SLR Project No.: 402.064843.00001

**RE: Discharge of conditions 7, 8, 9, 16 of full planning permission F/19/86233
Land to the North and East of Boorley Green, Winchester Road, Botley, SO32 2UA**

Condition 7 – Details of levels and retaining walls

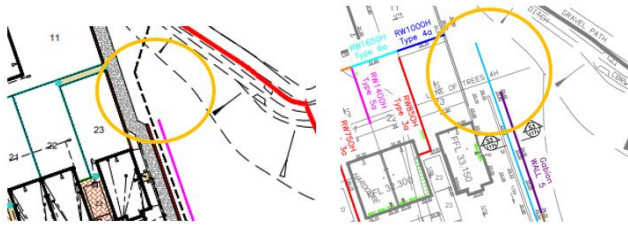
- *The retaining walls shown on the garden boundaries of plots 10, 11, 14, 19, 20, 21, 22, 23, 24, 25, 26, 27, 34, 35, 39, 40*
- *Return of the retaining wall at the northern end of the car park:*

Please see updated hard landscape plans VYH23647 12D-Sheets 1 - 4 and Open Space drawings VYH23647 21C Sheets 1 - 4.

The Retaining Wall Layout and Retaining Wall Details have been updated to the most current version and are attached. The Retaining Wall Layout shows that the wall to the east of Block E is now type 5c as opposed to type 5a.

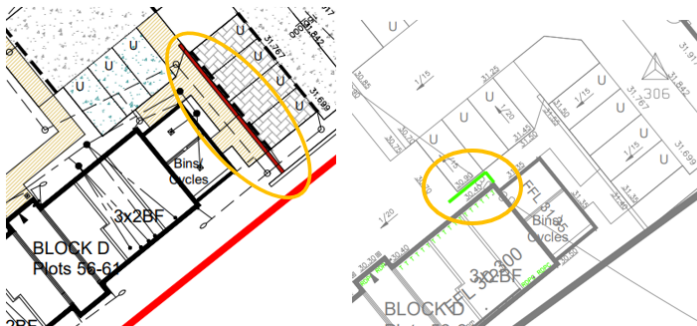
- Retaining wall and gabion wall shown on Retaining Wall Layout adjacent and to rear of Block B, but only gabion wall shown on Hard Landscape Proposals

Condition 16 – Garden design for Blocks B, C, D & E

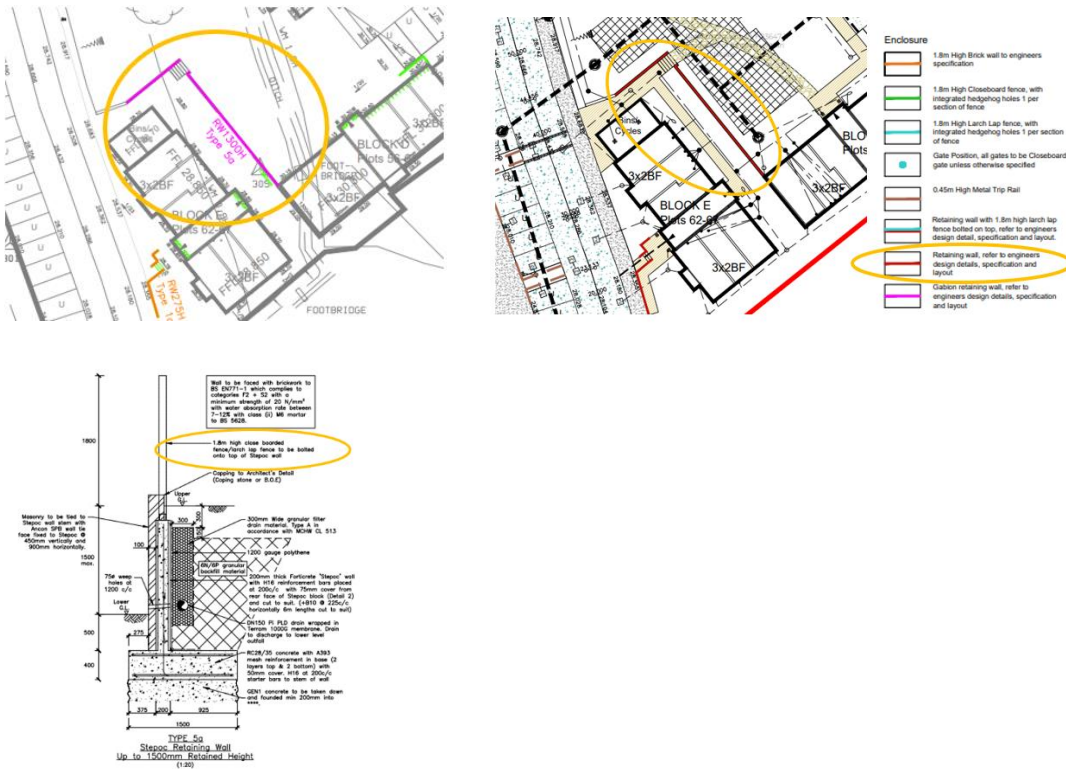
It was previously indicated that 1m-1.2m high railings need to be provided on top of the retaining wall to the east of Block E, rather than the proposed 1.8m high fence, to ensure a more satisfactory appearance and reduce the sense of enclosure for residents in Block E. Whilst the covering letter states that it has been amended to show a 1.8m high brick wall instead of a retaining wall with 1.8m fence on top, drawings 6663-MJA-SW-XX-DR-S-1170 rev T3 “Retaining Wall Layout” and 6663-MJA-SW-XX-DR-S-1179 rev C1 “Retaining Wall Stair Details” both refer to retaining wall Type 5a and drawing 6663-MJA-SW-XX-DR-S-1171 rev T2 shows Type 5a to be a 1.8m fence on top of the retaining wall and the key in the Hard Landscape Proposals refers to the engineers details. Please amend all relevant plans accordingly, noting the comment above about the later revisions of drawings 1170 and 1171 having been received on 10.8.22

As requested railings have been installed on top of the retaining wall to the east of Block E, rather than the proposed 1.8m high fence, to ensure a more satisfactory appearance, as shown in the images below:
